Agenda Item No. 7  
**PLANNING AND DEVELOPMENT SERVICES  
DEPARTMENT**

**RE:** Consideration of a Design Review: Final Architecture and Site Review for a single family home on Lot SS811, 2 Mountain Village Blvd., pursuant to CDC Section 17.4.11

**RE:** Staff Memo – Initial Architecture and Site Review (IASR) for Lot AR25, 125 Lawson Point

## APPLICATION OVERVIEW: New Single-Family Home on Lot AR25

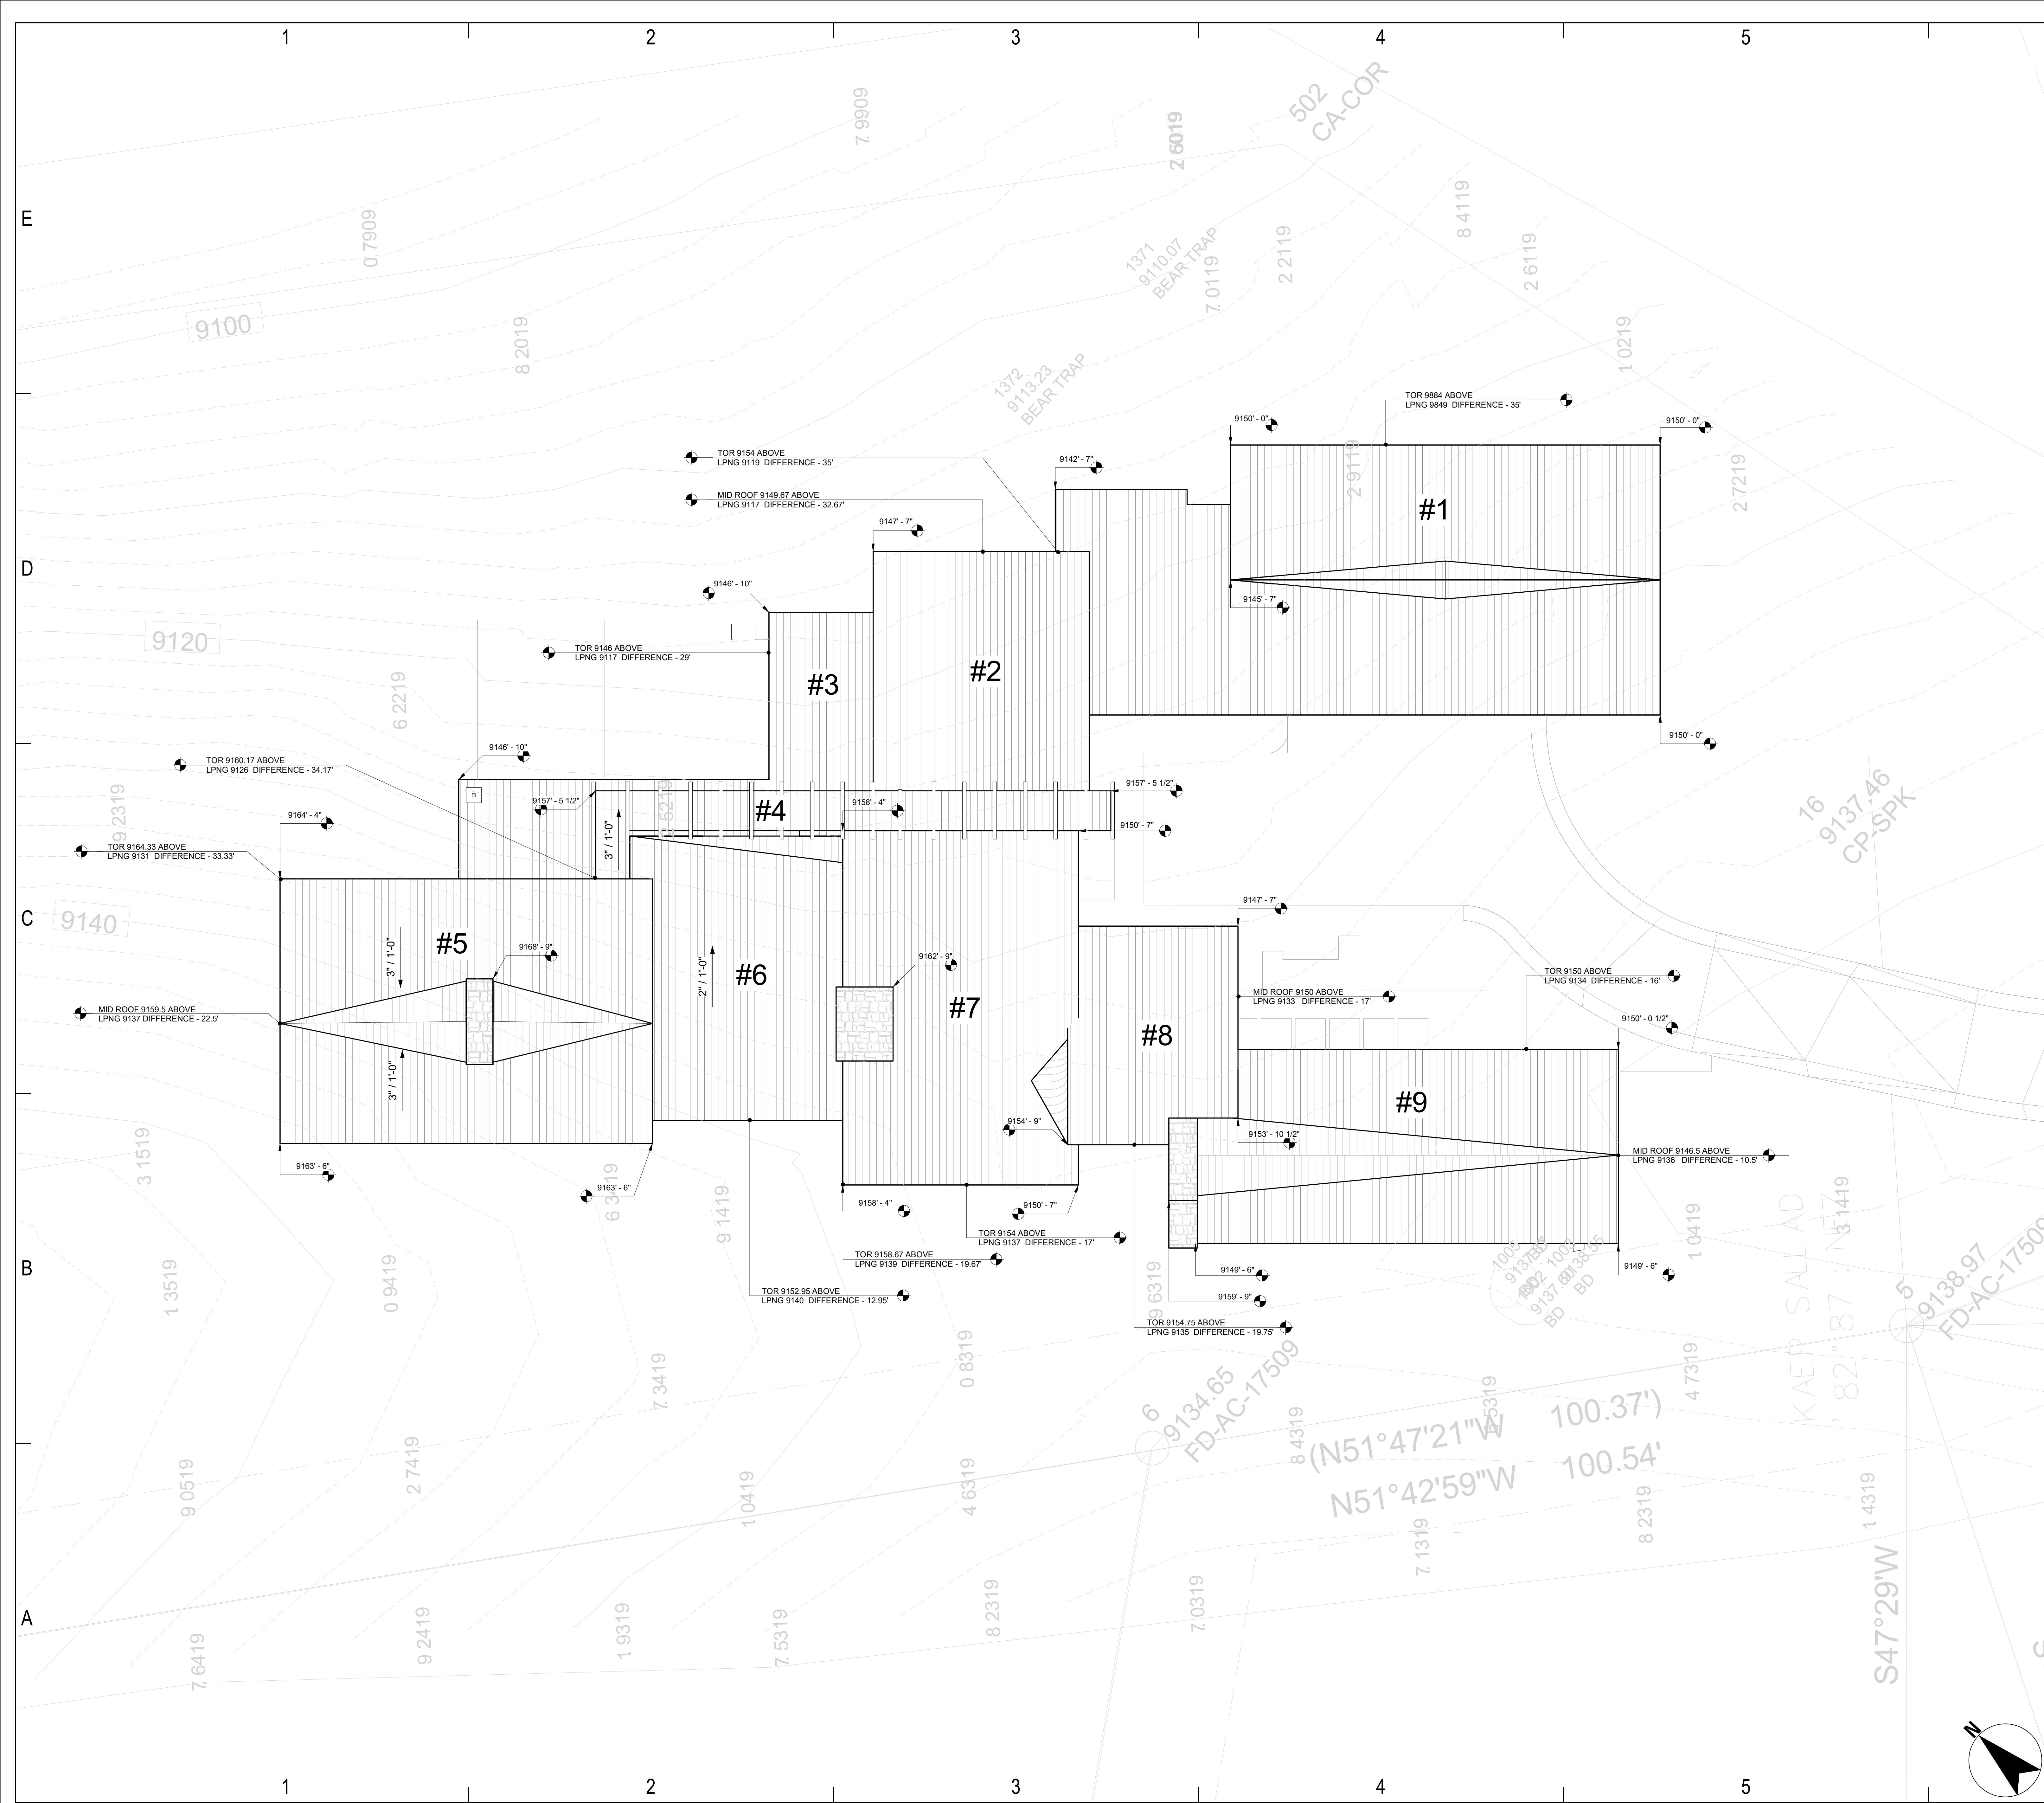
*demonstrated both in elevation and by a 3D parallel plane projection. The average height is shown at 22.096' and is also in compliance with allowable heights per the CDC.*

**SOUTH ELEVATION**

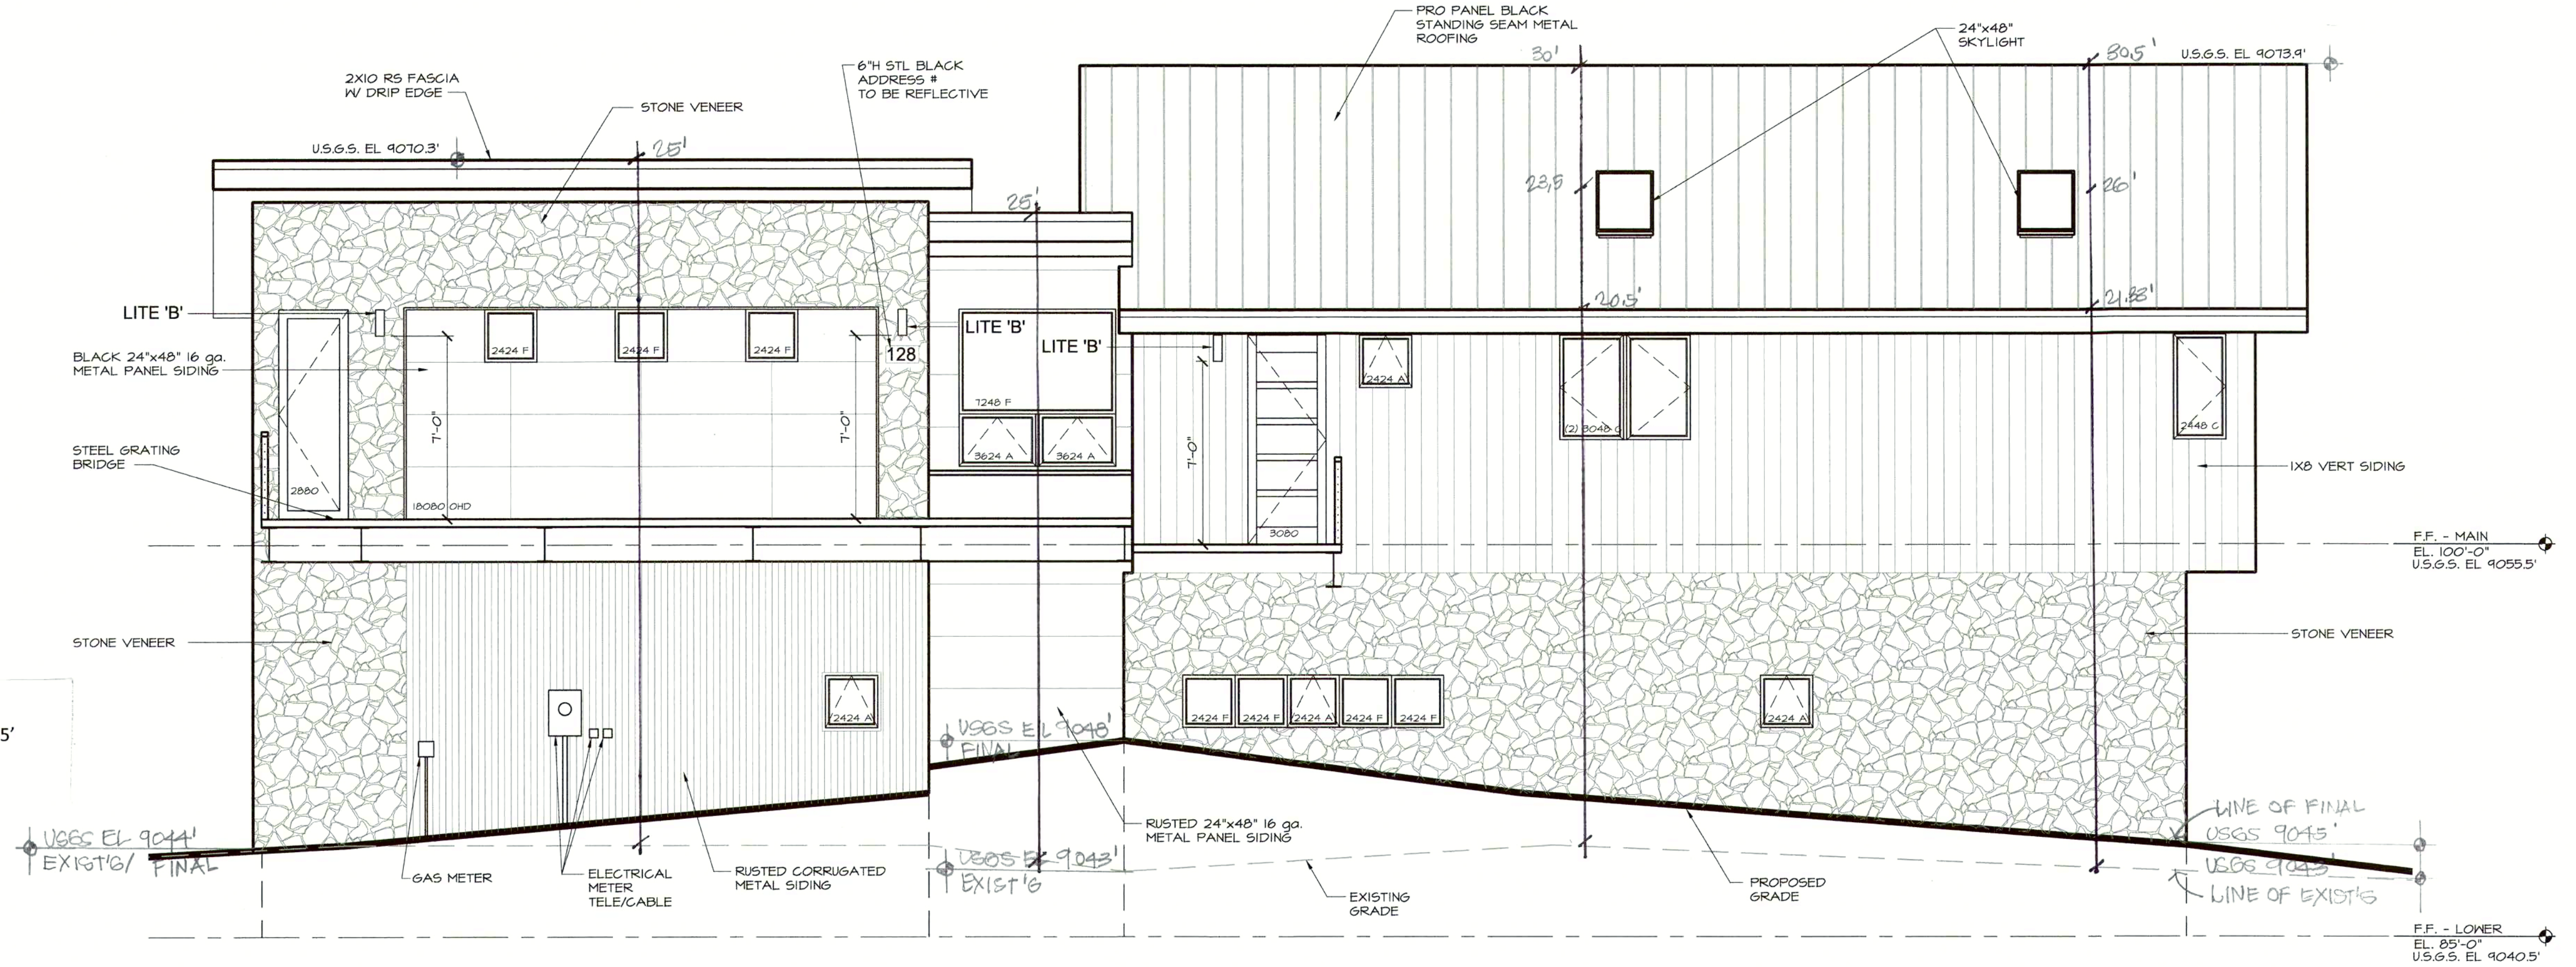
**Figure 7: Proposed Structure South Elevation (multiple roof forms)**
